SERVICE LETTER 215

DeHavilland DHC-2 Beaver 6000A, 6100A & DHC-3 Single Otter 8000A Hydraulic Pump Replacement

Aircraft Makes/Model(s):	Float Model(s):	Compliance: Optional	By: MAS
DeHavilland DHC-2 DeHavilland DHC-3	6000A, 6100A 8000A	Part Number: 1011601	Approved: DRH
		Date: 1/18/2024	Revision: C

DISCONTINUED
HYDRAULIC PUMP 6A09000-029

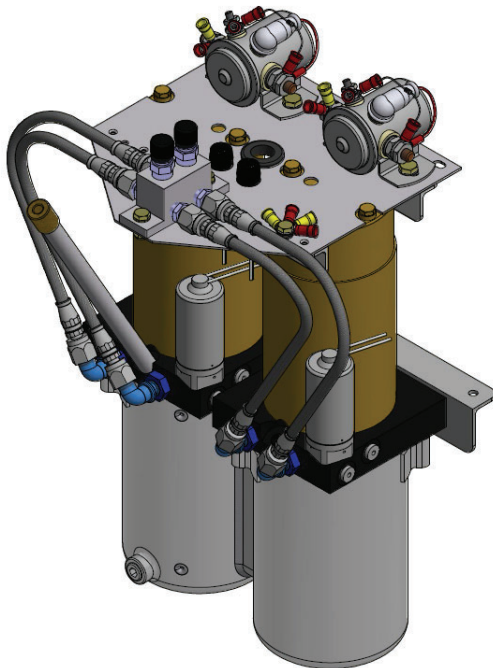
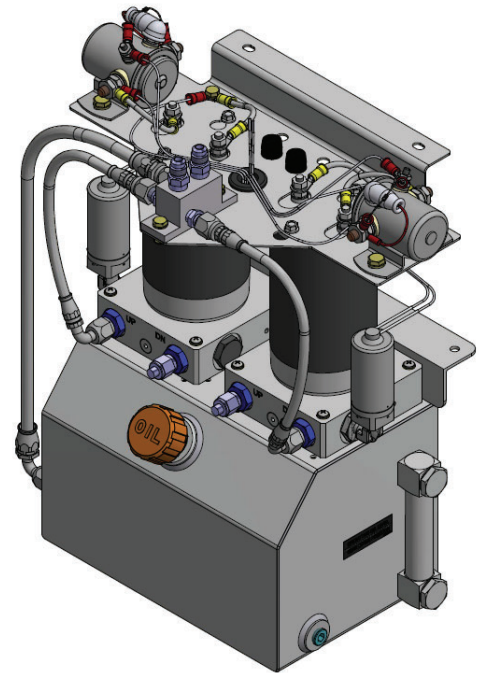
Hydraulic Pump Assembly p/n 6A09000-029 has been discontinued. This service letter provides the option to replace it with a new pump p/n 1011404.

NEW
HYDRAULIC PUMP 1011404

SOLENOID SCHEMATIC

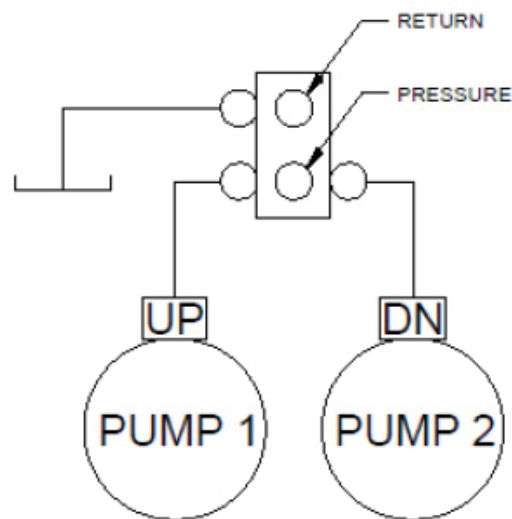
1. Pull Pump 1 and Pump 2 circuit breakers.
2. Remove and cap both pressure and return hydraulic lines on hydraulic pump manifold 6A09000-027.
3. Remove GA1 and GA4 wires (12 ga) from electrical solenoids terminal "D" on hydraulic power pack 6A09000-029.

HYDRAULIC SCHEMATIC

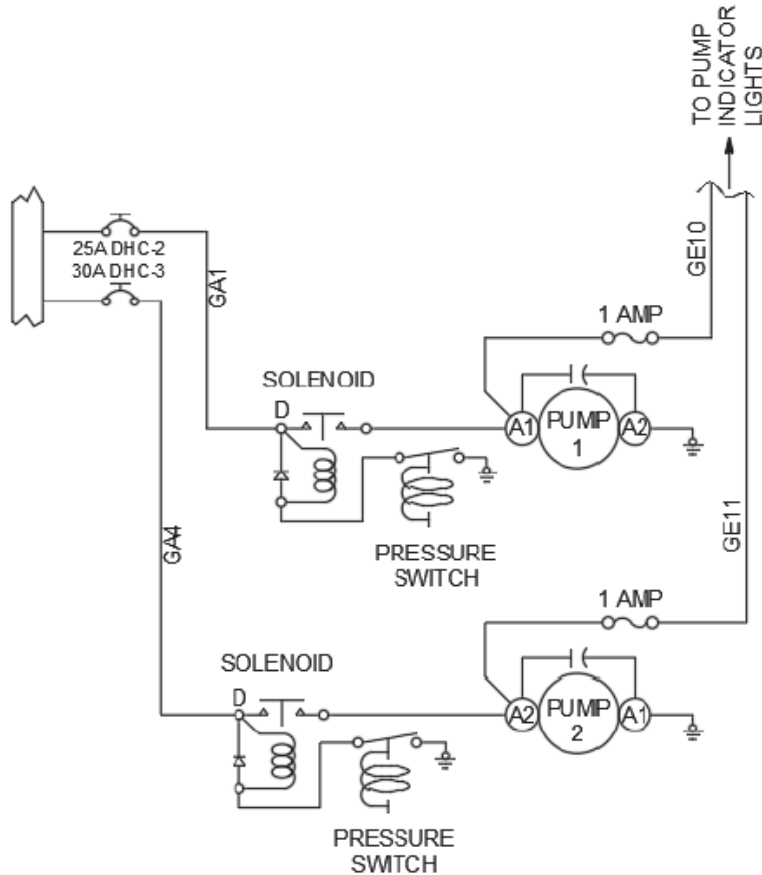
4. Cut GE10 and GE11 wires (20 ga) at butt splice connection.
5. Unbolt and remove hydraulic power pack 6A09000-029 from pump mount assembly.
6. Install new hydraulic power pack 1011404 onto pump mount assembly using existing hardware.
7. Install pressure and return line to hydraulic pump manifold. Refer to hydraulic schematic.
